CONSERVATION COMMISSION AGENDA

Date: October 11, 2018
Time: 7:00 pm
Place: City Hall, Room 204

10/11/18
 1a 1 WELLS AVE - PROPOSED BRIDGE + TRAIL LAYOUT

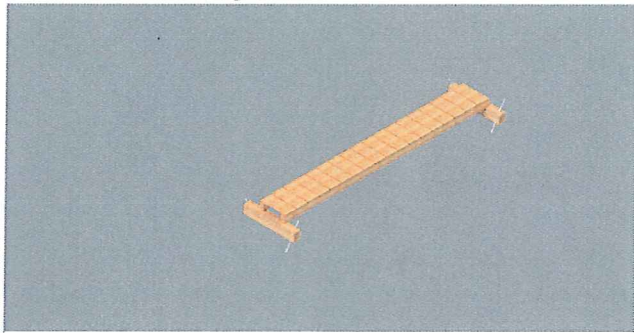
- o Applicant is proposing to create a new mulched trail to connect two portions of the existing Helen Heyn Riverway Trail to allow users to avoid the Wells Ave sidewalk. The new trail will require a small footbridge across Country Club Brook.
- o Applicant is proposing to create a wooden pedestrian footbridge spanning the banks of Country Club Brook, downstream of and below the level of the culvert under Wells Ave. (per Engineering's/Utilities' request).

- o Approximately 10 s.f. of RFA will be altered by the new bridge footings.
- o Minimal vegetation clearing near the stream will be required to allow the bridge to be placed and trail to be located. The vegetation in this area consists mainly of bittersweet and poison ivy. The remainder of the new trail alignment is currently grass. No trees will be cut or damaged.
- o Fill in floodplain will be minimal and will not increase the horizontal extent and level of flood waters during peak flows (since the bridge is down-gradient of the culvert). The bridge will be a simple box construction of pressure treated wood, secured into the bank using pieces of rebar through footings.
- o All work will be done by hand.

- o The bridge has been requested by members of the Conservators for years.
- o This bridge has been approved by the City Engineering and Utilities Departments.

o Staff Recommendations: Vote to close the hearing and issue an OOC with the following special conditions.

- Before work may begin, the project leader(s) must schedule and conduct a pre-construction site visit with the Conservation Agent to confirm the timeline, confirm the flagging of the trail layout, confirm the details of the bridge installation, and confirm installation of the DEP file number sign.

(2a) COBB PLACE - PROPOSED LAYOUT

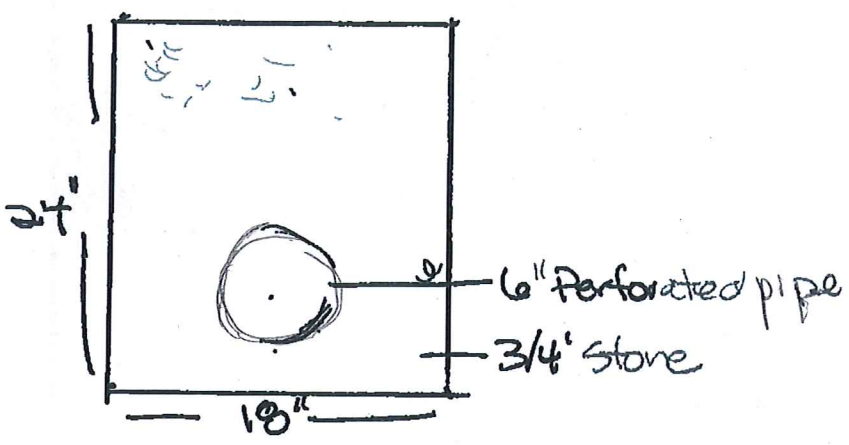
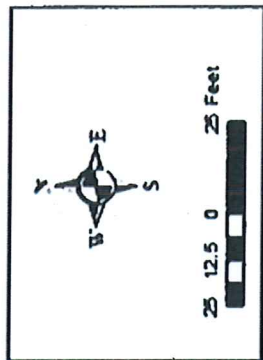
- Staff Notes
 - **Project Summary:** Applicant is proposing to excavate the existing ~22' wide gravel road and asphalt apron (at Quinobequin Rd.), remove unsuitable soil, add material to crown the road, pave, and install country drainage (perforated pipes in stone trenches) in segments along the road sides.

- **Impact Summary:**
 - A 90' stretch of Cobb Place is within outer riparian zone (RFA)
 - Cobb Place will change from an existing 22-24' wide gravel roadway to an 18-20' wide paved roadway. The proposed "increase" in impervious surface area within RFA is roughly 1980 s.f.

- Applicant is proposing country drainage for stormwater management, so runoff will be reduced, reducing ponding at the intersection and improving stormwater treatment.

- Trees and tree roots that line portions of the road will be avoided.
 - Site plan sketches, site photos, and details of the proposed country drainage have been received and seem appropriate for a private roadway improvement project.

- Staff Recommendations: Vote to close the hearing and issue an OOC with the following special conditions.
 - Project must be executed as illustrated on the approved plans.

- Infiltration trenches must be installed as illustrated on the approved plans.
- 3. NOI – Needham Street/Needham-Highland Bridge – road reconstruction and bridge rehab – DEP file #239-815**
